**ENGINE SYSTEMS, INC.**

Report No. 10CFR21-0076
SEPTEMBER 22, 1997

10CFR21 REPORTING OF DEFECTS
AND NON-COMPLIANCE

COMPONENT: EMD Air Start Motors #40047506 & #40047507

Fig.4-3 - Typical Air Starting System Diagram

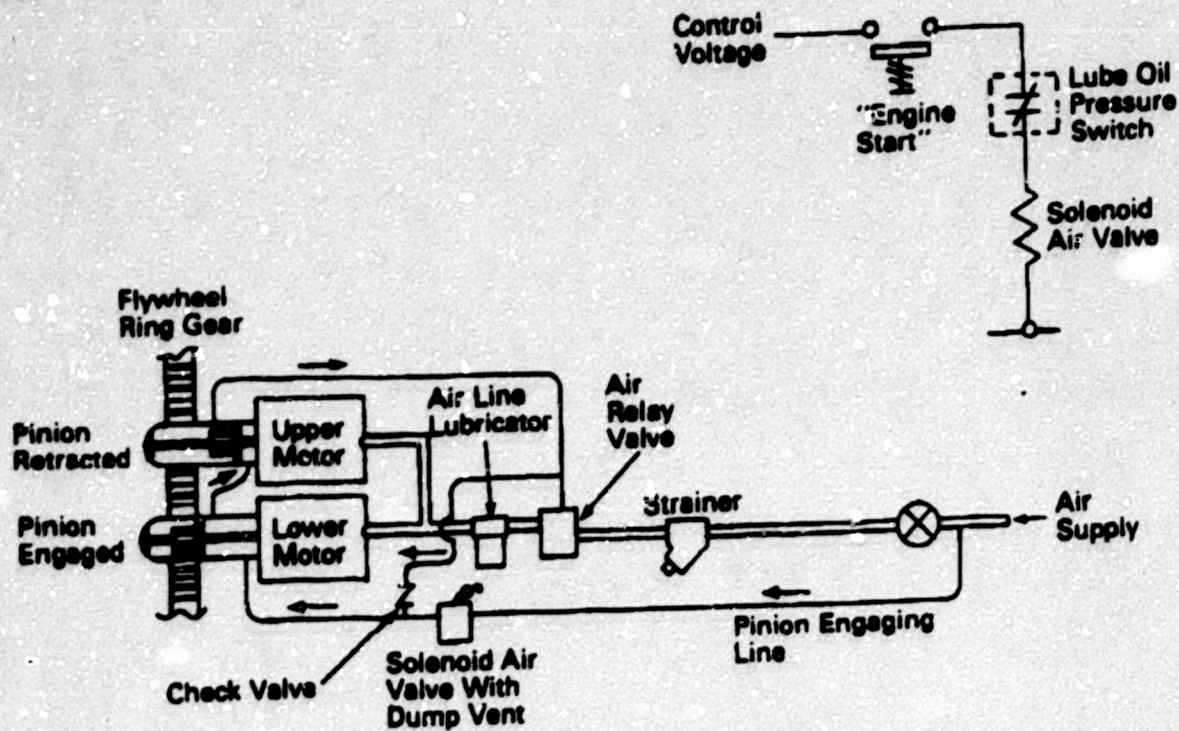
The EMD design pipes the two air motor pinion lines in series before going to the main air valve "activate" input. The intent of this design is to pre-engage the pinion gear (achieve mesh between the pinion gear and the engine ring gear) before starting air is supplied to the motor to begin engine rotation (see Exhibit 1).

EMD has recently performed starting motor tests at their facility with I-R using both "old" and "new" style air motors. The results show that the "old" style air motor is not a pre-engagement type (although, I-R thought it was) and therefore it allows air motor rotation during pinion abutment. The testing also demonstrated that the "new" style starter is a positive engagement type and therefore it prevents motor rotation during pinion abutment. Under most starting scenarios, the pinion gear will properly mesh with the engine ring gear, the engine begins to crank and starts as normal. The pinion gear has chamfered teeth which allows the two gears to mesh easily; therefore, gear abutment is rare. If gear abutment does happen, the following will occur:

This motor is a pre-engagement type; therefore, engine rotation is prevented because the pinion has not traveled a sufficient distance to release an activate air signal to the main air valve. The engine fails to start.

EMD feels that the pre-engagement operation of the current design "new" style starter decreases engine starting reliability and therefore is not acceptable for use on the EMD engine. The "old" style starter has demonstrated many years of reliable engine starting on the EMD diesel engine and its continued use is recommended. I-R is investigating reinstatement of the "old" style starter for exclusive use by EMD. They are also looking at modifying the "new" style starter so that it performs identically to the "old" style.

Replace the "new" style air start motors with the "old" style motors. At this time, the "old" style starter is only available through a rebuild program offered by ESI. Eventually, I-R may be able to reinstate the "old" style starter and make it available as a new part and/or modify the current "new" style starter to make it perform identically to the "old" style.
